INDESIT company

Model type:
AVTL83EU

Commercial code:
F033196

n1040345: Replacement of drum lock button TL EVOII.

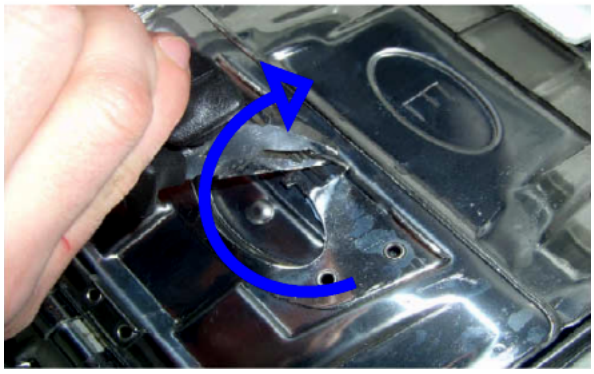
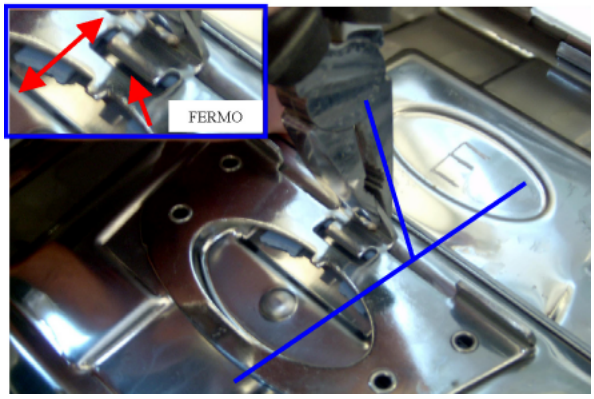
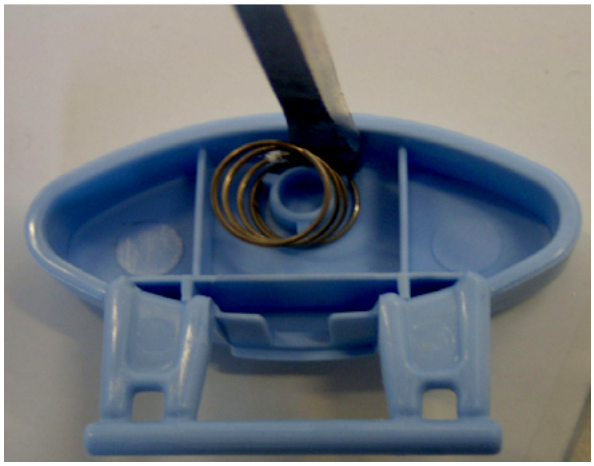
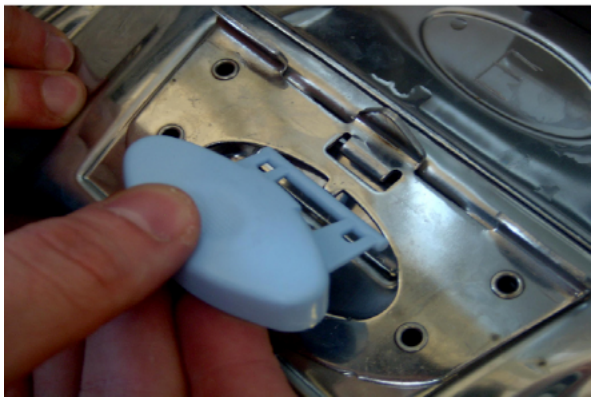
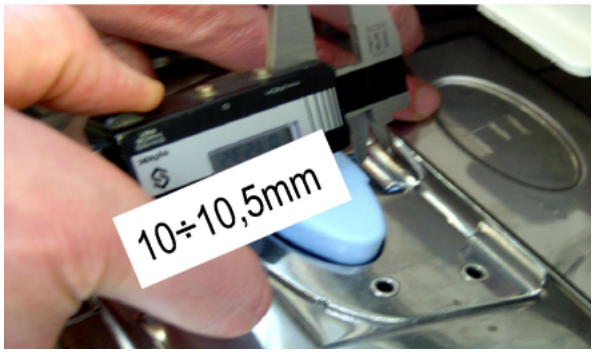
Tools and material needed: pliers, screwdriver, gauge, spring P/N Sat 114989, button P/N Sat 114990.

1) turn the central tip of the catch in the direction shown (FIG.1);

2) bring the tip to a vertical position and ensure that the broken button is disengaged from the catch restraint and can be removed (FIG.2);

3) remove the remaining part of the button with the aid of a screwdriver, taking care not to scratch the doors (FIG.3);

4) pre-assemble spring to button (FIG.4);

5) insert button between catch and door (FIG.5);

6) bring the button into position and arrange the spring in its location in the door (FIG.6);

7) turn the central tip of the catch in the direction shown to return it to its starting position (FIG.7);

8) check the distance between button and catch (FIG.8);

9) check correct operation of the button when opening and closing the doors (slight inclination errors of the catch can result in faulty closing of the doors) (FIG.9).

n1040382: Drain pump with bayonet-style filter - top Loading Brembate

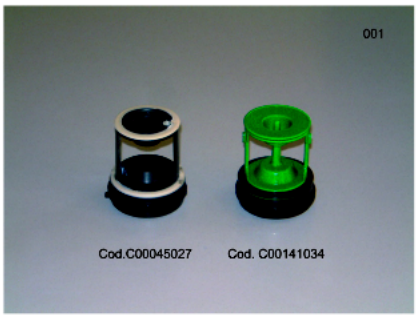
From serial no. 51021.0001 a new drain pump with bayonet-style filter has been installed on all top loading washing machines manufactured in Brembate.

New parts:
C00141862 - Drain pump
C00141034 - Pump filter kit

Premodification parts:
C00111409 - Drain pump
C00045027 - Pump filter kit

The new parts can be used instead of premodification ones.

N1040404FIG1

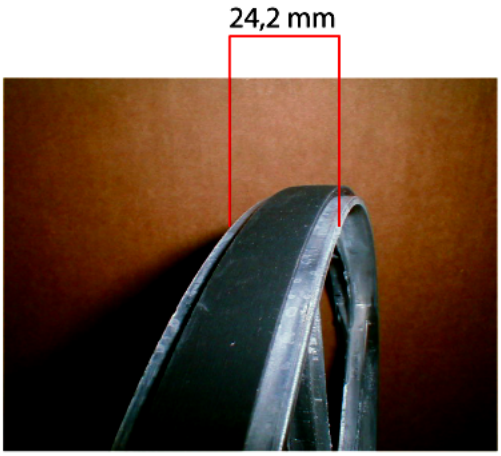
From serial no. 51202.0001 the pulley track has been widened from 21.2mm to 24.2mm (see picture N1040404FIG1).

new pulley
C00142832 - D280 24.2 mm track

Premodification pulley
C00083912 - D280 21.2 mm track

The new pulley can also be used on premodification versions of the models referred to in this release.
